SUBJECT: Administrative Approval for Petition No. 2013-079 Joseph and Sylvia Okoye

Attached is the revised site plan for the petition above. This request allows the modification of the proposed site plan as listed below. Since these changes do not alter the intent of the development and meets the requirements of the Charlotte Zoning Ordinance Section 6.207 Alterations to Approval, minor changes, I am administratively approving this plan. Please use these plans when evaluating requests for building permits and certificates of occupancy.

Okoye Medical Office Building

A-201

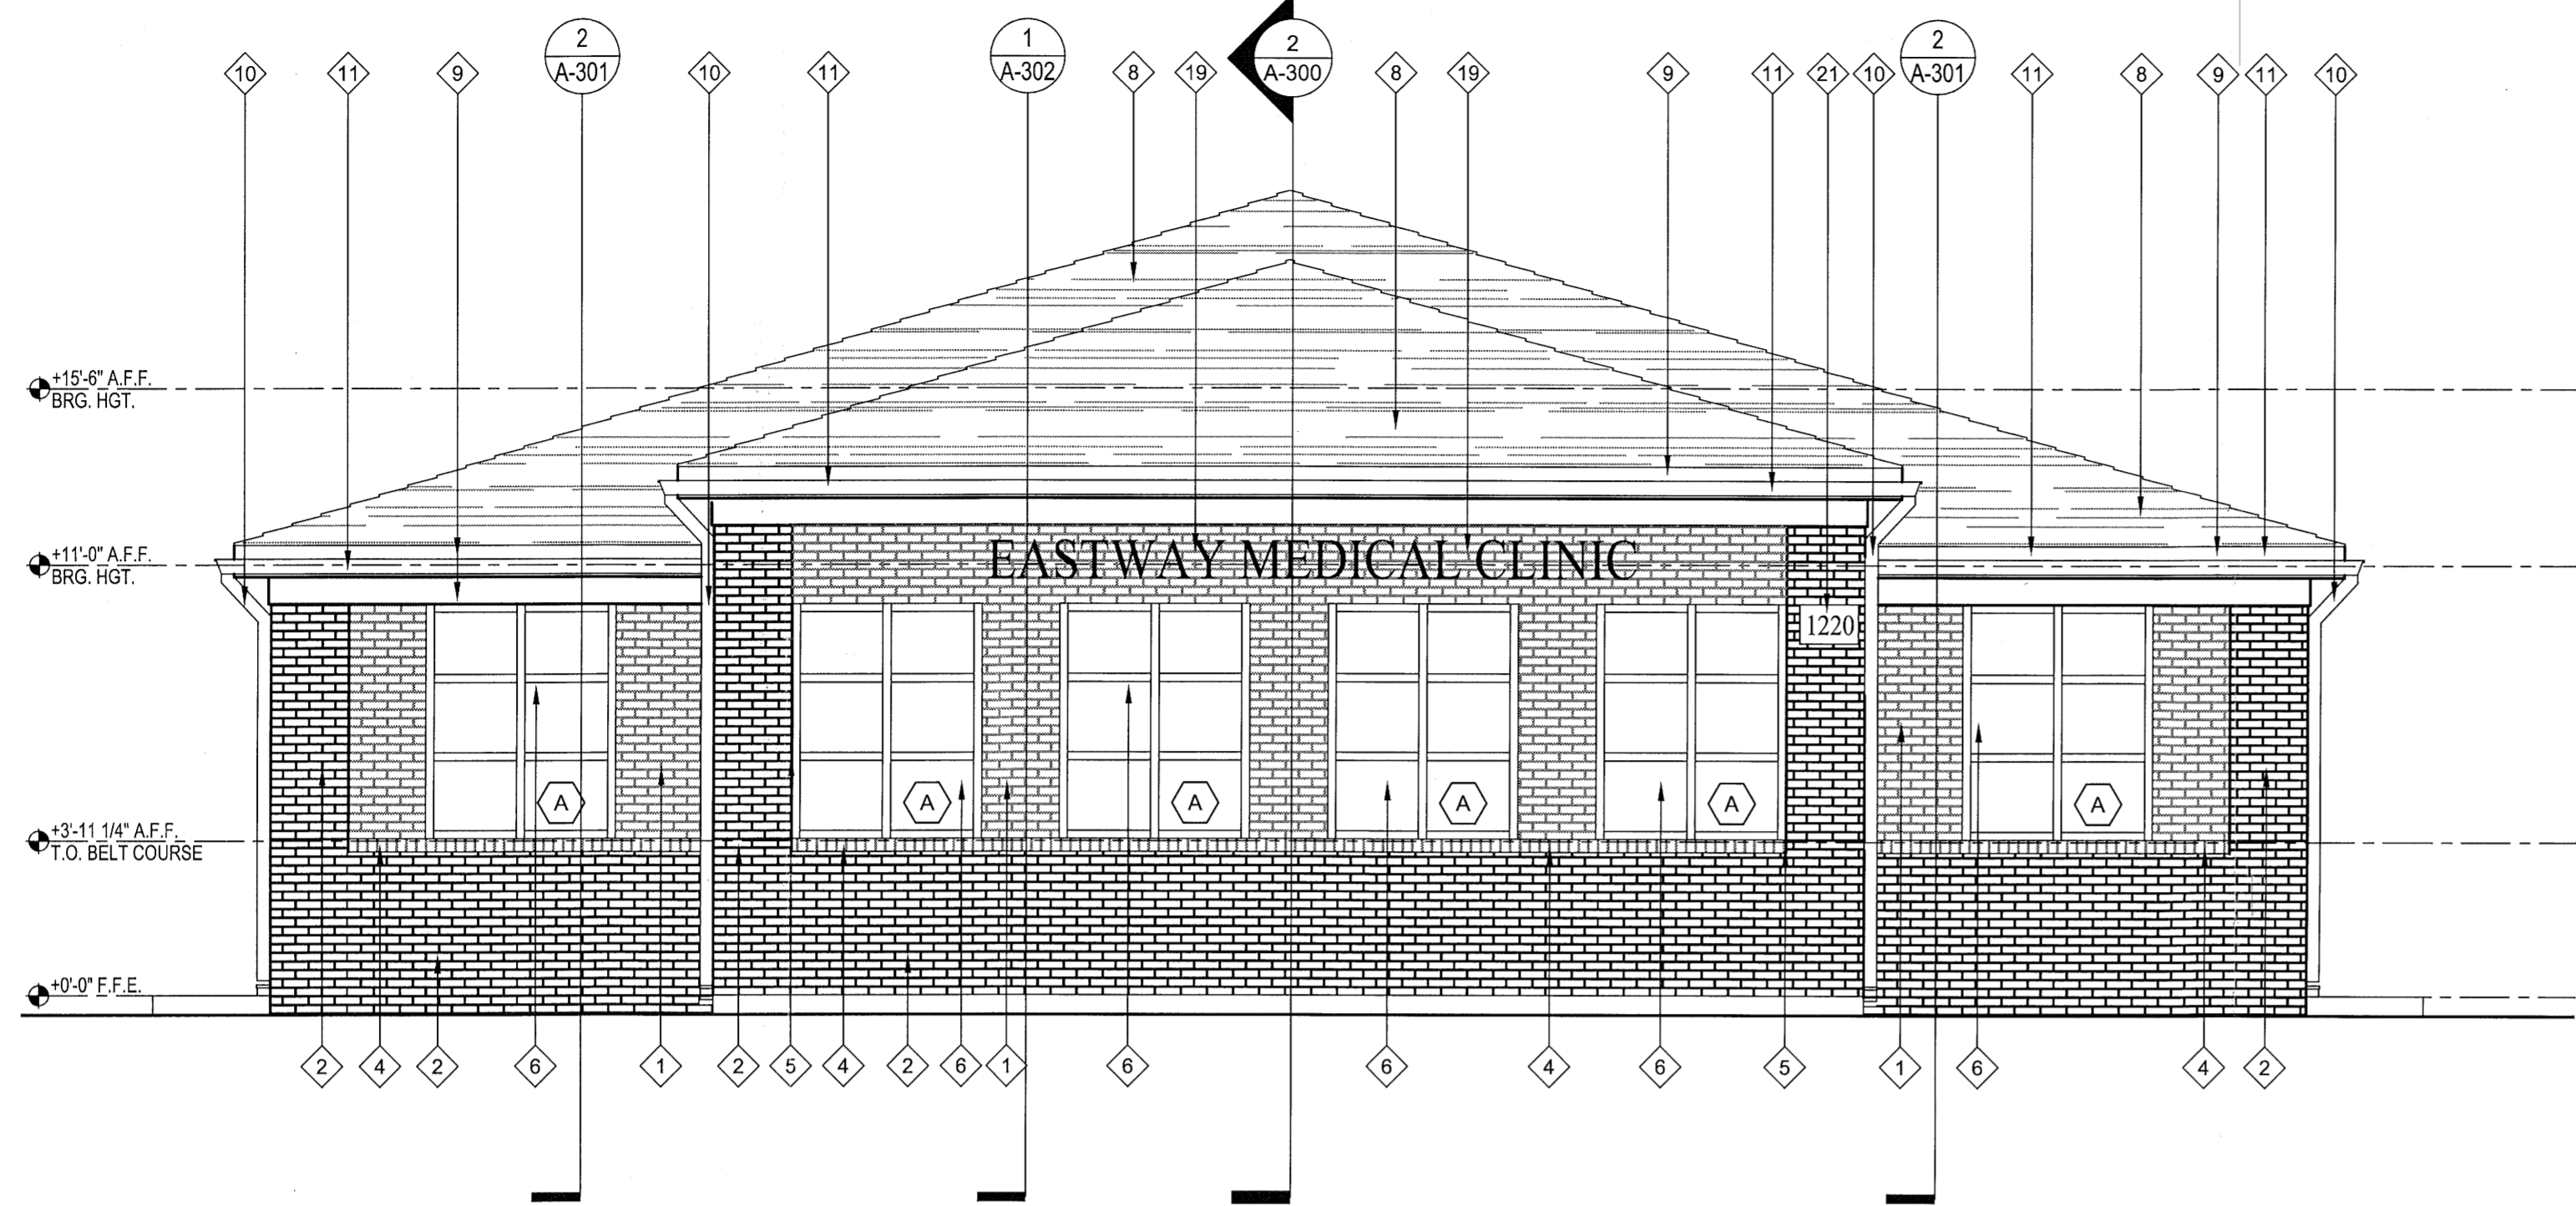
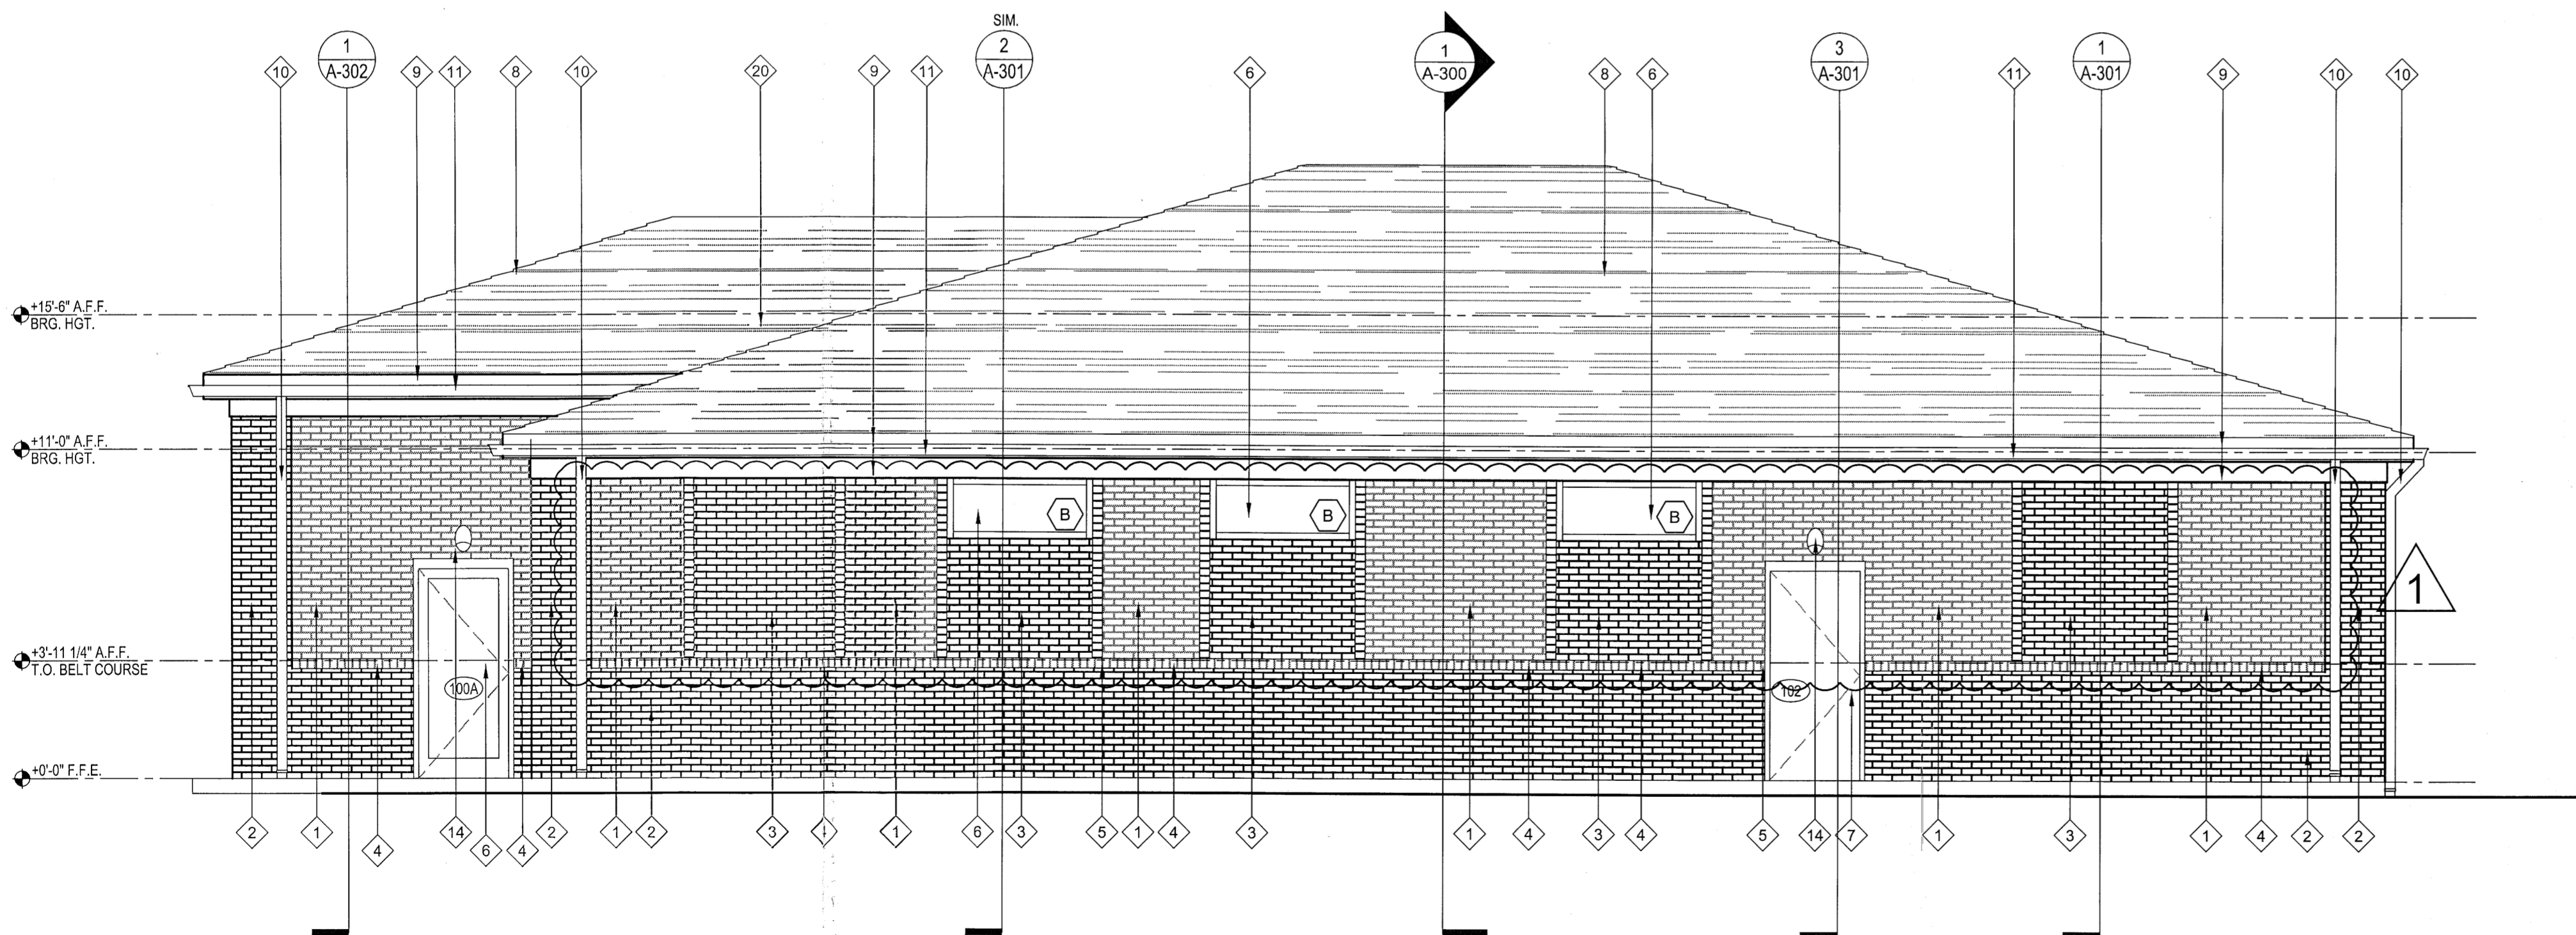
- Building Elevations
- Landscaping Plan

LANDSCAPING PLAN

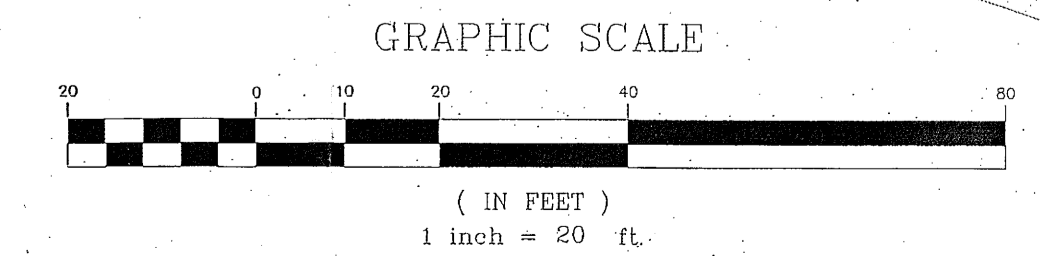
- #1. 3-10-15 REVISE BUILDING PER OWNER
- #2. 3-23-15 WATER CONNECTION AND ROOF LEADER PIPING
- #3. 4-7-15 GATEWAY REVIEW COMMENTS-SIGHT DISTANCE PLAN AND PROFILE
- #4. 5-7-15 ZONING COMMENTS
- #5. 5-7-15 LAND DEVELOPMENT COMMENTS
- #6. 6-9-15 LAND DEVELOPMENT COMMENTS
- #7. 6-24-15 CMUD COMMENTS
- #8. 7-7-15 ZONING COMMENTS
- #9. 7-7-15 CMUD COMMENTS
- #10. 7-15-15 ZONING COMMENTS
- #11. 8-25-15 ZONING COMMENTS
- #12. 8-26-15 ZONING COMMENTS-ADDED GRAPE MYRTLES AROUND BUILDING
